**EXPLANATION OF SIGNIFICANT
DIFFERENCES, PORT HEIDEN RADIO
RELAY STATION**

PORT HEIDEN, ALASKA

**FINAL
MAY 2017**

Alaska Department of Environmental Conservation
Comments on the Draft Explanation of Significant Differences for Port Heiden RRS dated March 2017
Commenter: Louis Howard (ADEC), Comments Developed: April 20, 2017

FIGURE NO.:
3-1

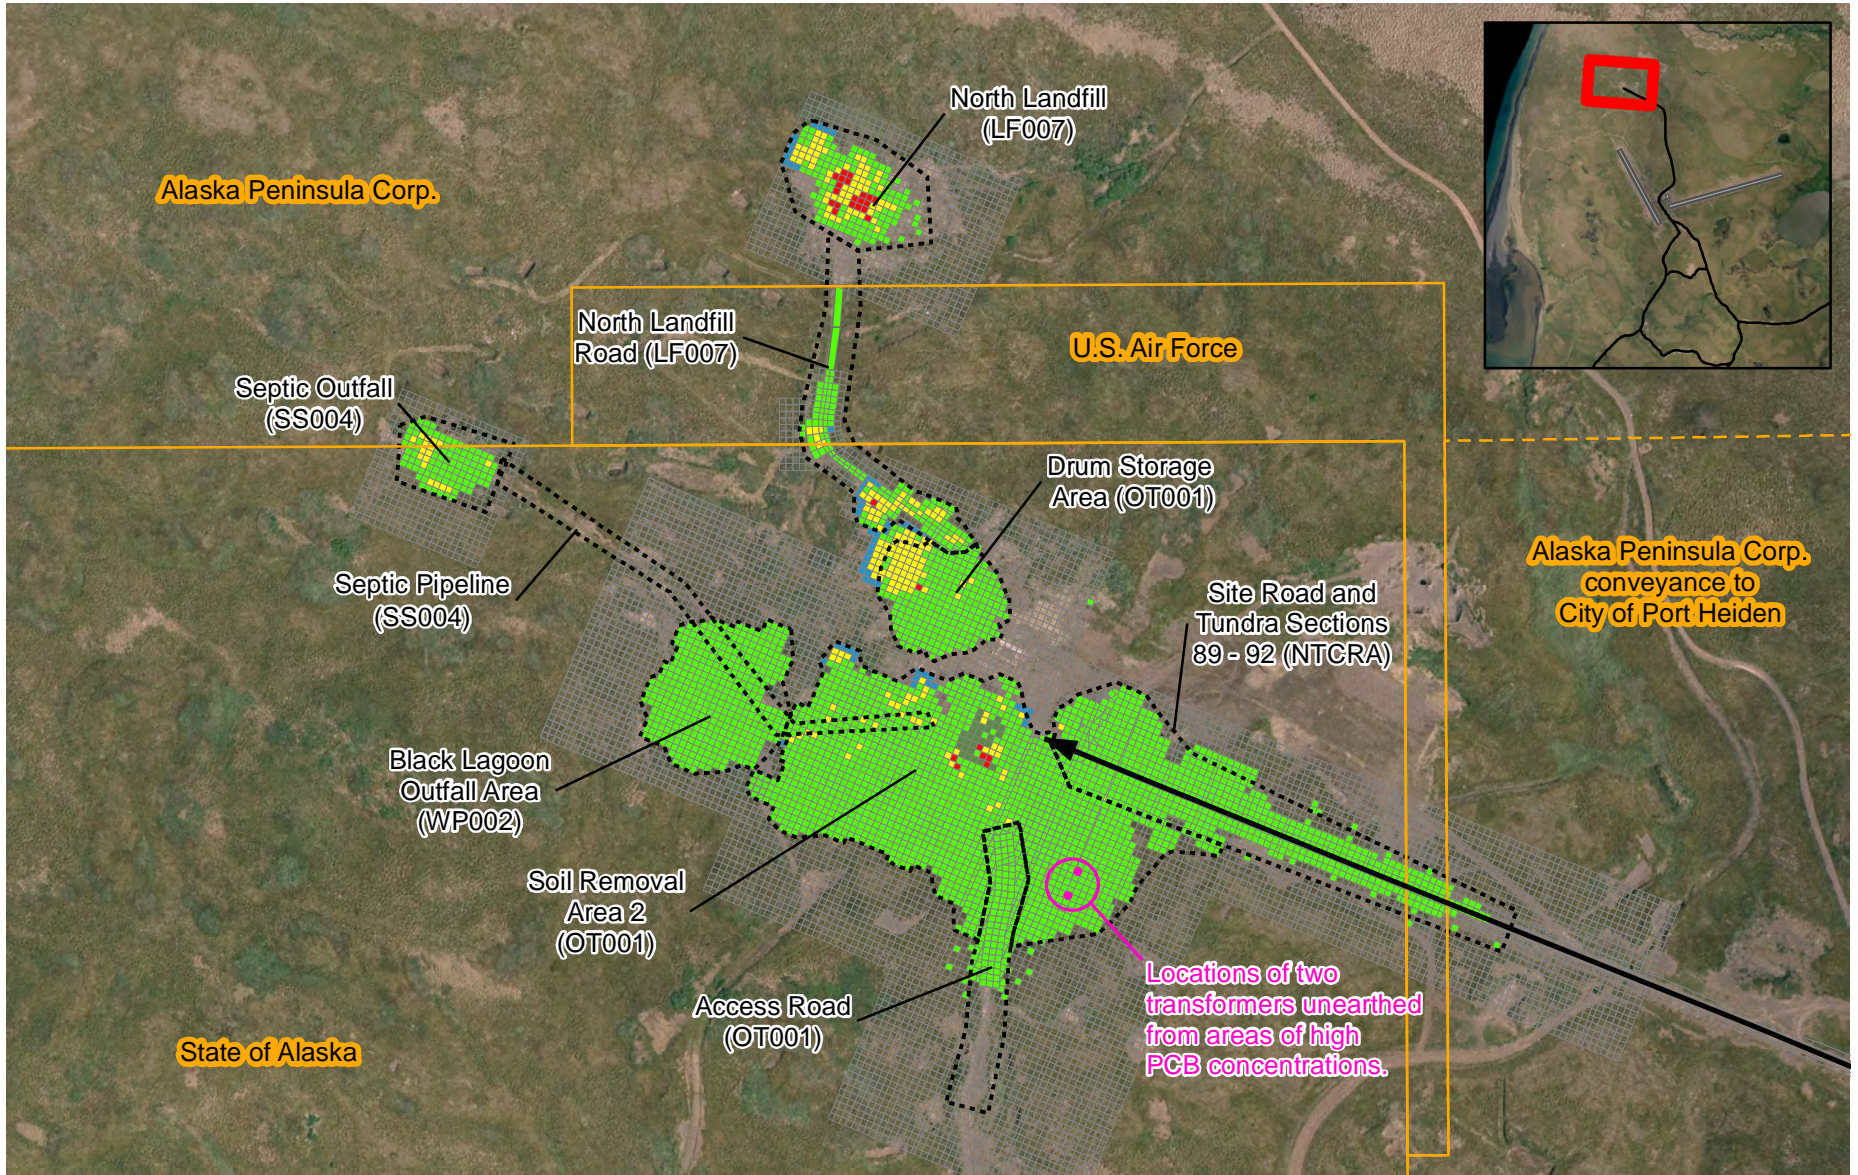
2.	19 of the PDF	Fig. 3-1	<p>Radio Relay Station Overview Please indicate to the reader on the figure where the two transformers were found with the highest PCB soil contamination levels recorded to date at the RRS.</p>	<p>Amended – Locations will be added to figure 3-1.</p>
